# Alaska Region Research Vessel

## Changes to Support Lengthening Option

12 August 2009

### Tank And Space Changes Aft of Frame 60

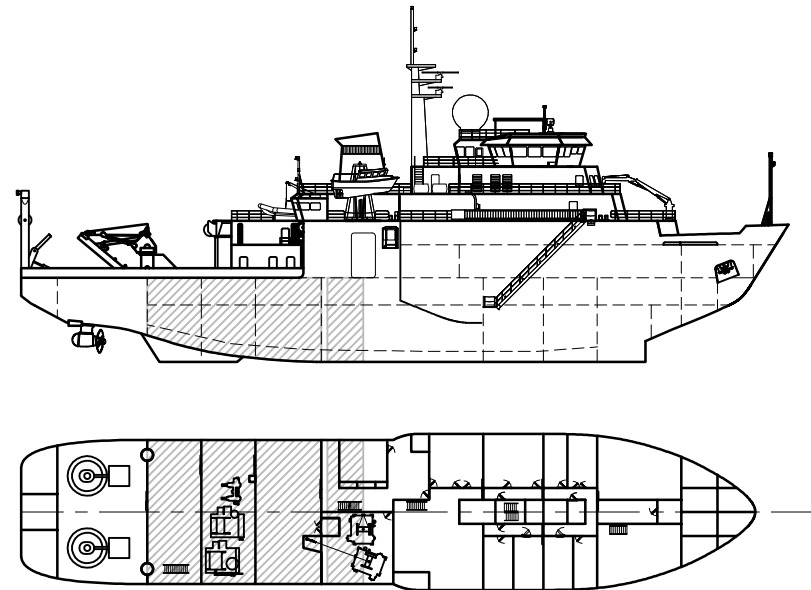
Existing Space Designations	New Space Designations	Notes:
1st Platform	2-67-0 SCIENCE HOLD	Same SCIENCE HOLD	Space widened
	2-79-0 WINCH ROOM	2-78-0 WINCH ROOM	Space widened
	2-67-2 BOSUN'S WORKSHOP	2-87-0 BOSUN'S WORKSHOP & STORES	Spaces combined
	2-79-2 BOSUN'S STORES		
	2nd Platform	3-67-1 F.O.	3-67-01 ANTI-ROLL TANK
3-67-2 F.O.		3-67-0 ANTI-ROLL TANK EQUIPMENT	
3-67-3 F.O.		3-67-1 F.O.	
3-67-4 F.O.		3-67-2 F.O.	
3-77-2 F.O. OVERFLOW TANK		3-78-4 F.O. OVERFLOW TANK	
3-79-1 F.O.		3-76-0 F.O.	
3-79-2 F.O.		3-76-1 F.O.	
3-79-3 F.O.		3-76-2 F.O.	
3-79-4 F.O.		3-87-0 F.O.	
		3-87-1 F.O.	
	3-87-2 F.O.		
	3-90-0 THRUSTER ROOM	3-96-0 THRUSTER ROOM	
	3-105-0 VOID	3-11-0 VOID	
	3-105-1 LINE LOCKER	3-11-1 LINE LOCKER	
	3-105-2 LINE LOCKER	3-11-1 LINE LOCKER	
Inner Bottom	4-67-0 TRANSDUCER WELL	4-67-0 TRANSDUCER WELL	
	4-67-0 SWB	4-67-1 SWB	
	4-67-1 VOID	4-67-2 SWB	
	4-67-2 VOID		
	4-79-0 SWB	4-78-1 SWB	
	4-79-1 SWB	4-78-2 SWB

The main modifications with the option are: lengthen the vessel by 12 feet and incorporate a controlled passive anti-roll tank.

The 12 foot lengthening is accomplished by adding 12 feet of parallel mid-body, main deck and below, aft of frame 60. The machinery space remains the same length with the aft bulkhead at frame 67. Spaces aft of frame 67 and forward of frame 96 have a revised configuration.

A U-shaped anti-roll tank is located between the 1st platform and innerbottom, from frame 67 to frame 78, inboard of the wing bulkheads. Space for the anti-roll tank equipment is provided between the 1st and 2nd platforms from frame 67 to frame 73 and from centerline to 13 feet port of centerline.
